END PROJECT SEARSBURG NH-010-1(48)

PROJECT NAME: SEARSBURG	
PROJECT NUMBER: NH 010-1(48)	
FILE NAME: z12B404bdr.dgn	PLOT DATE: 6/16/2014
PROJECT LEADER: E. ATKINS	DRAWN BY: M. BRADLEY
DESIGNED BY: M. BRADLEY	CHECKED BY: E. ATKINS
PLAN SHEET 2	SHEET 17 OF 45

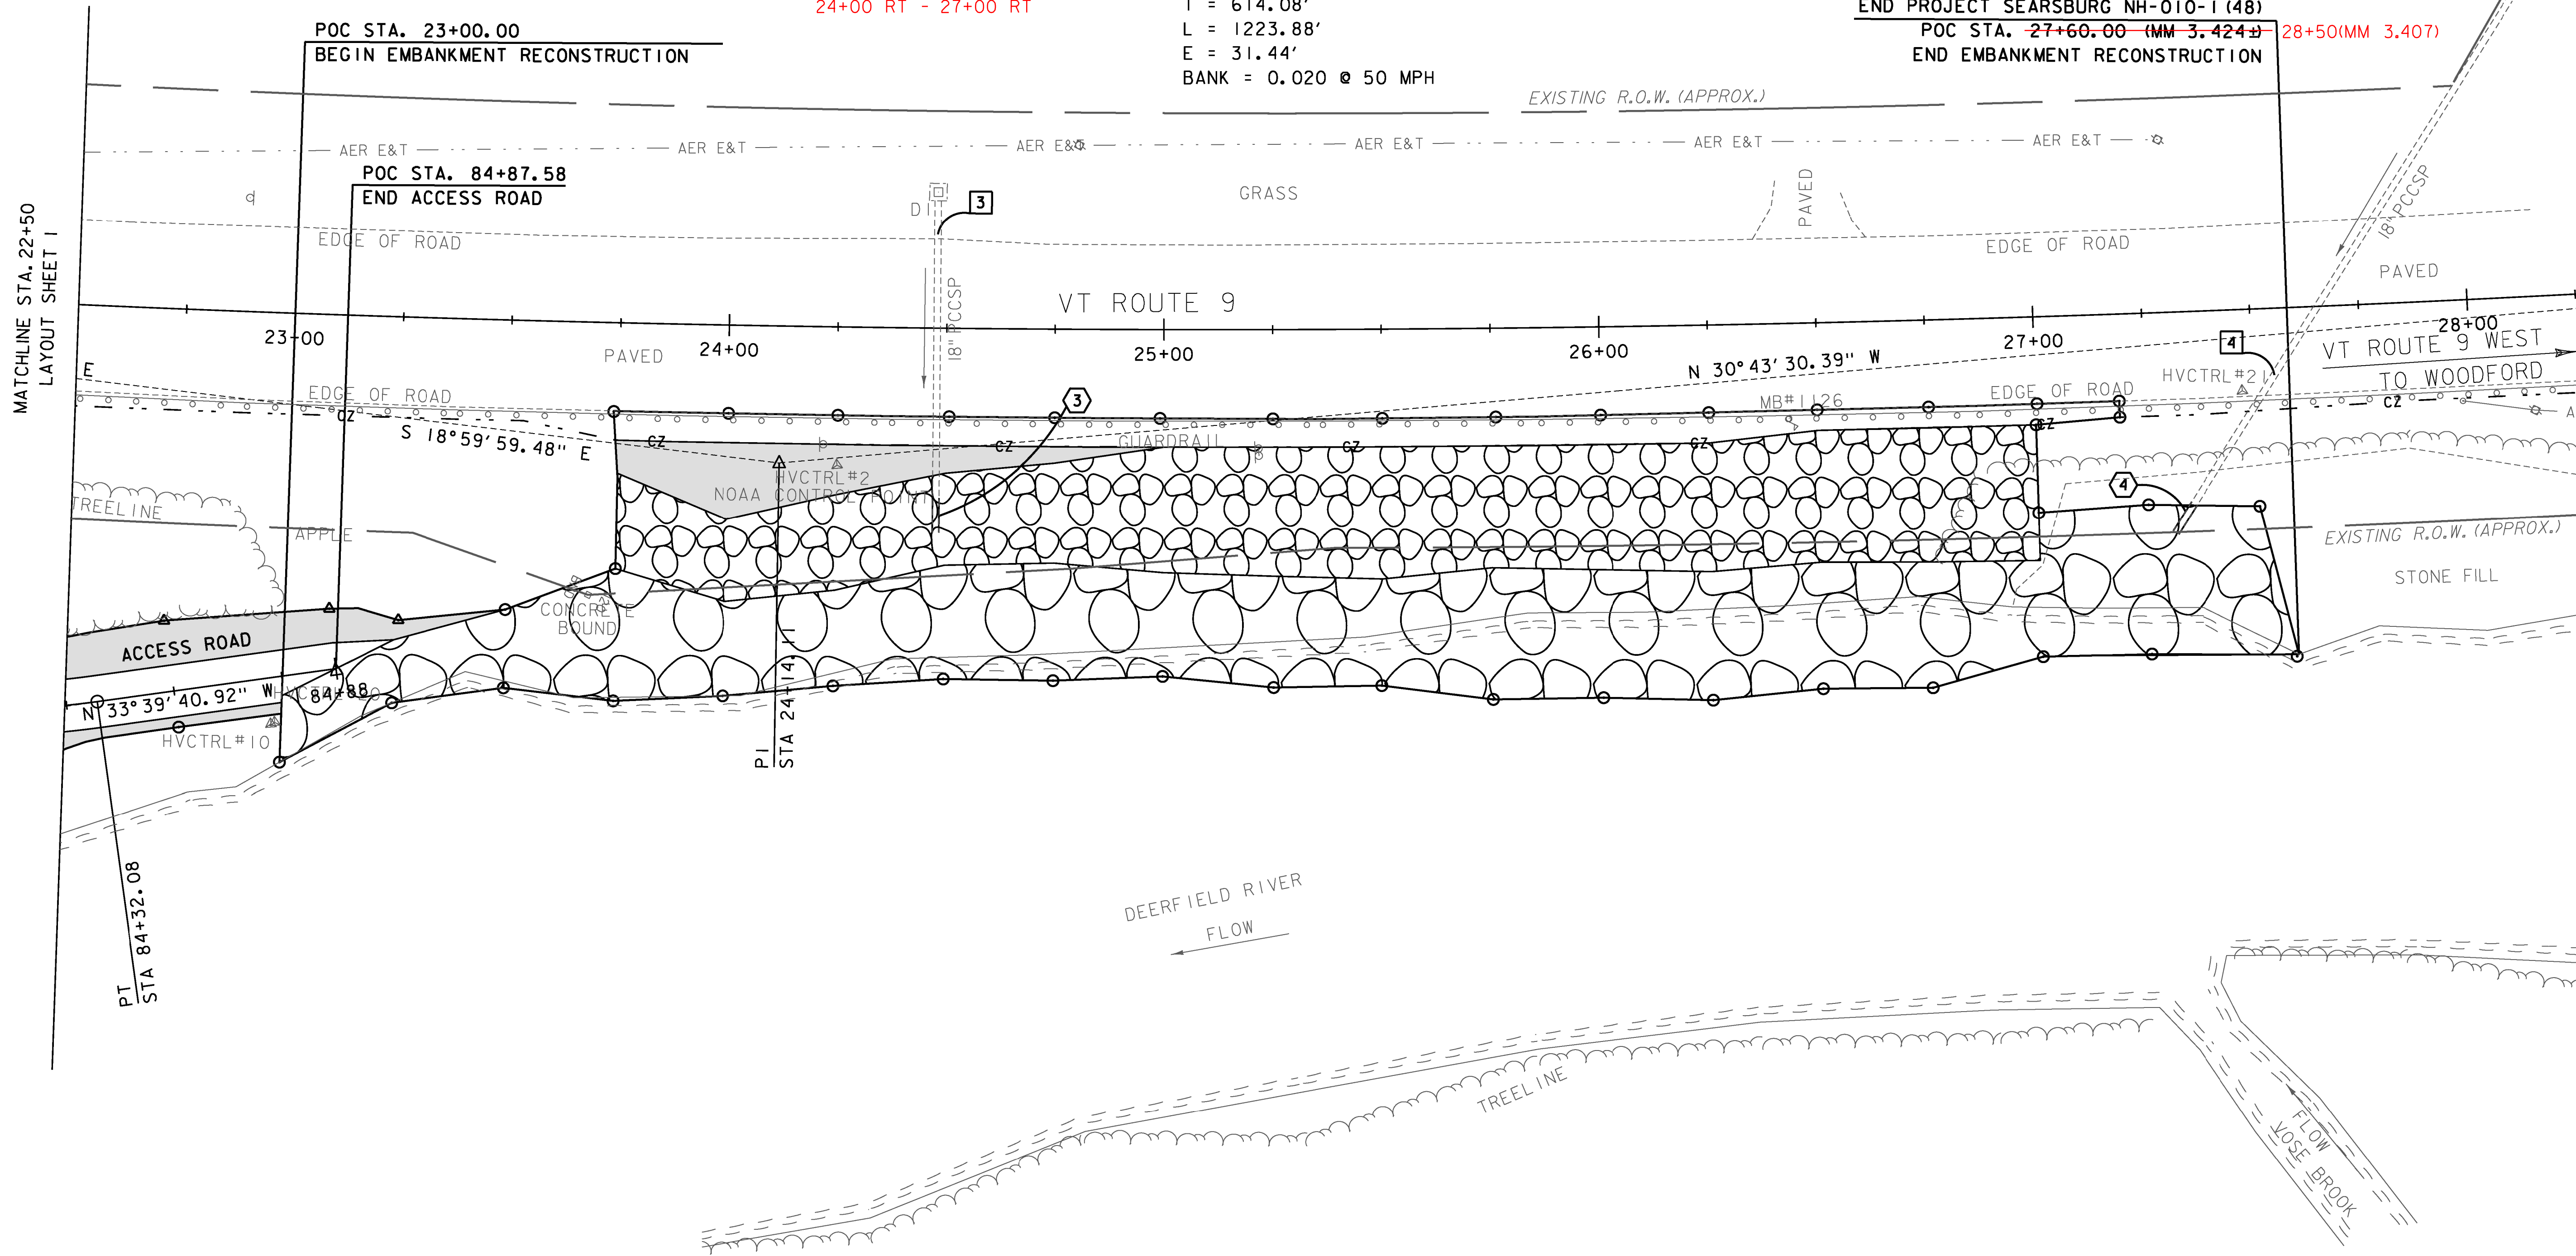
~~23+75.0 RT - 27+20.0 RT~~
NOT USED

23+00.0 RT - ~~27+60.0 RT~~ 28+50 RT

~~23+75.0 RT - 27+25.0 RT~~
~~24+00 RT - 27+00 RT~~

23+75.0 RT - ~~27+00.0 RT~~
00 28+50

POC STA. ~~27+60.00 (MM 3.424)~~ 28+50(MM 3.407)
END EMBANKMENT RECONSTRUCTION
